First Floor Plan 1:100

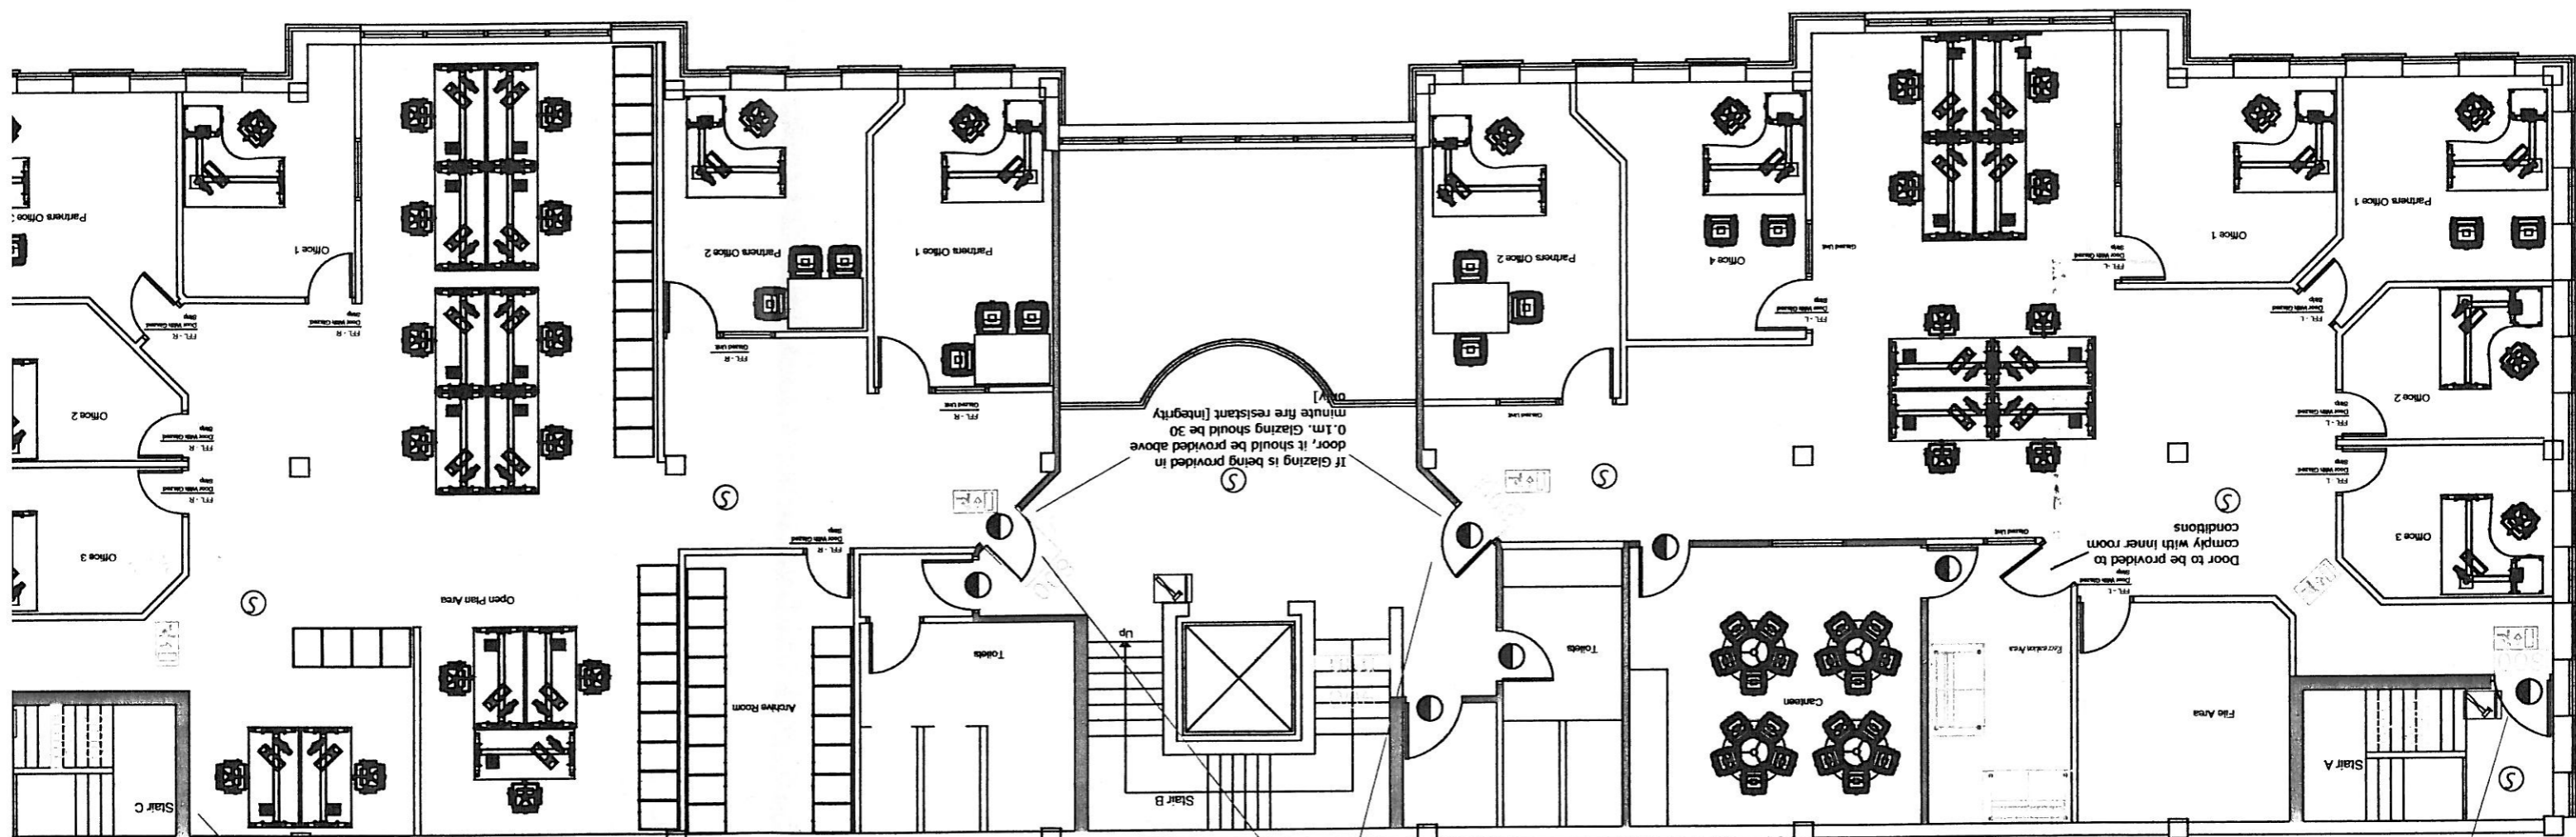
Door to be held open with an electro magnetic hold open device.

If Glazing is to be provided in door or wall enclosing canteen. Glazing is to be provided above 1.1m. Glazing will be 30 minute fire resistant [integrity only]

Door to be held open with an electro magnetic hold open device.

Fire barriers to be carried to the underside of the roof/floor construction and fire stopped

If Glazing is being provided in door, it should be provided with fire resistant [integrity only]

If Glazing is being provided in door, it should be provided above 0.1m. Glazing should be 30 minute fire resistant [integrity only]

Door to be provided to comply with inner room conditions
